# Access Compliance Report

## Public Rights-of-Way

### (Curb Ramps)

Intersection ID: 10011781	Main Street: PIERSON_DR	Cross Street: N/A	Location:	N
ADA ID: C13756BE2FA8	Ramp Type: Perp	Initial Pass/Fail: Fail	Overall Compliance: No	Severity Score: 12.5
Codes/Mitigation Info/Possible Solution		Field Measurements/Component Compliance

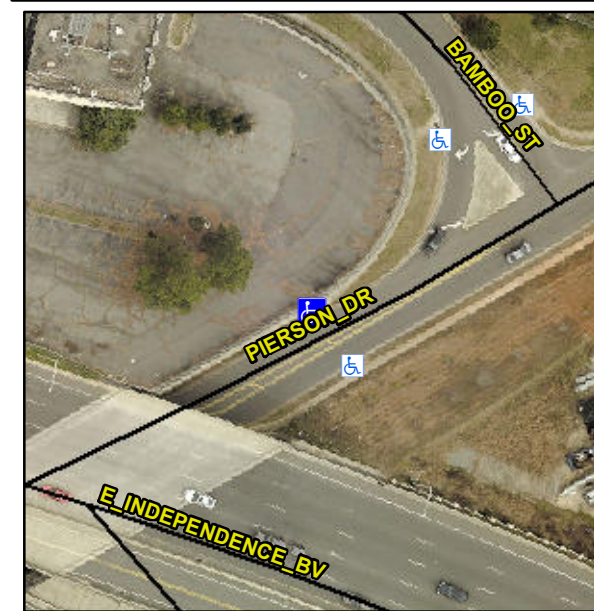
**Not Found, R304.5.3**

Compliance	Description	Data	Compliance	Description	Data
N/A	Ramp Length (in)	103.0	Yes	Ramp Slope (%)	6.1
Yes	Ramp Width (in)	64.0	No	Ramp XSlope (%)	5.5
N/A	Flare Type LT	N/A	N/A	Flare Type RT	N/A
N/A	Flare Slope LT (%)	N/A	N/A	Flare Slope RT (%)	N/A
N/A	Flare Traversable LT?	N/A	N/A	Flare Traversable RT?	N/A
N/A	Landing Length (in)	N/A	N/A	DWS Provided?	N/A
N/A	Landing Width (in)	N/A	N/A	DWS Contrast?	N/A
N/A	Landing Slope (%)	N/A	N/A	DWS Length (in)	N/A
N/A	Landing X Slope (%)	N/A	N/A	DWS Full Width?	N/A
N/A	Landing Curb? (Y/N)	N/A	N/A	DWS Offset (in)	N/A
N/A	Shared Landing?	N/A			
N/A	Gutter Ponding?	N/A	N/A	Gutter Slope (%)	N/A
N/A	Gutter Lip Ht (in)	N/A	N/A	Gutter X Slope (%)	N/A
N/A	Painted X Walk1?	No	N/A	Painted X Walk2?	N/A
	X Walk 1 Direction	To S		X Walk 2 Direction	N/A
N/A	X Walk 1 Width (in)	N/A	N/A	X Walk 2 Width (in)	N/A
	X Walk 1 Slope (%)	0.5		X Walk 2 Slope (%)	N/A
	X Walk 1 X Slope (%)	5.8		X Walk 2 X Slope (%)	N/A

**Remove & Replace Entire Ramp.**
